DATE: March 25, 2014

FILE REF.: CDRC CASE #S 12-5451 Cielo Colorado Estates Preliminary Development Plan,
Plat and Variance

Cielo Colorado LLC., Applicant, James W. Siebert, Agent, request Preliminary Development Plan and Plat approval for a 24-lot residential subdivision on Tract 15A-2 of the Eldorado at Santa Fe Subdivision consisting of 246.30 acres more or less. The Application also includes a request for a Variance of Ordinance No. 2008-10 (Stormwater Prevention and Stormwater Management) to allow access through a 100-year floodplain without an all-weather crossing.

TYPICAL ROADWAY CROSS SECTION
NTS

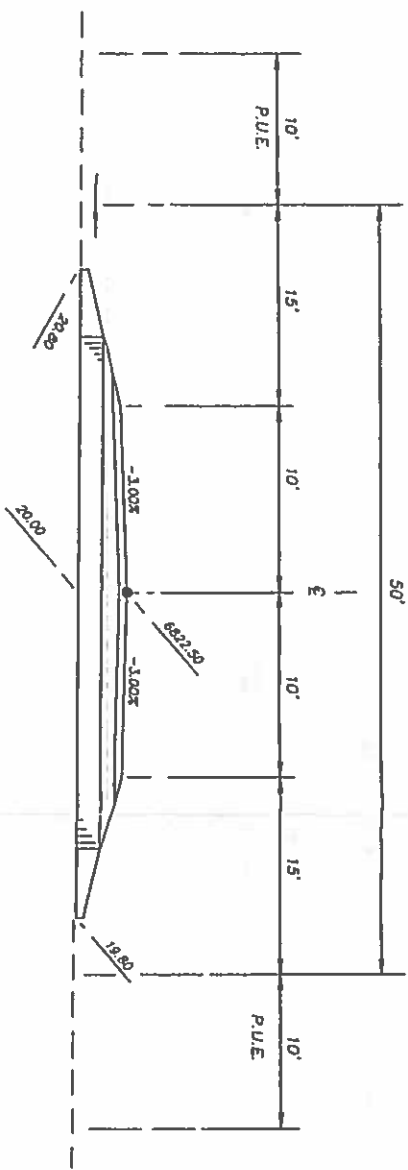
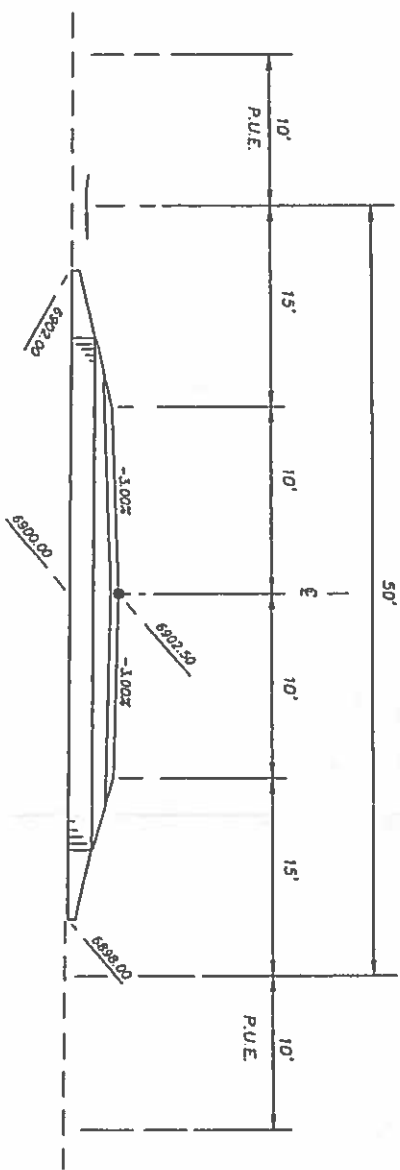
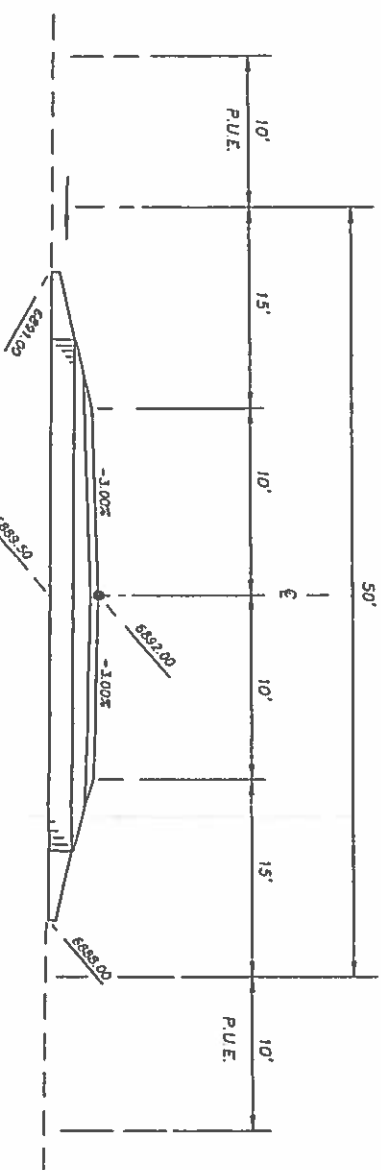
Note: Plan Sheet Page 6 Paved Road Section A-A appears to have a typo that should read "24' Paved Road Section" not 20'.
